Product Change Notification

2025-03-03

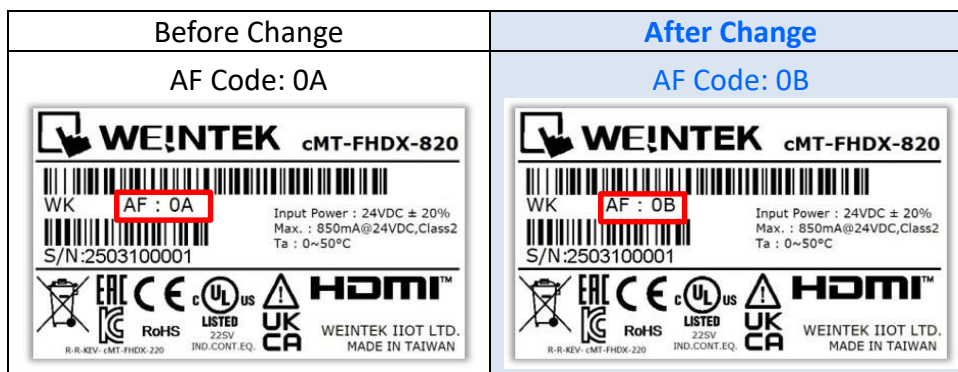
To simplify external data access, the cMT-FHDX-820 features a microSD interface, requiring EasyBuilder Pro V6.09.02 or later for operation. The model now includes five I/O interfaces: USB, Ethernet, Serial Port, HDMI, and microSD, enabling seamless cross-device data access for easier analysis and remote maintenance.

The following illustrates the difference in product design.
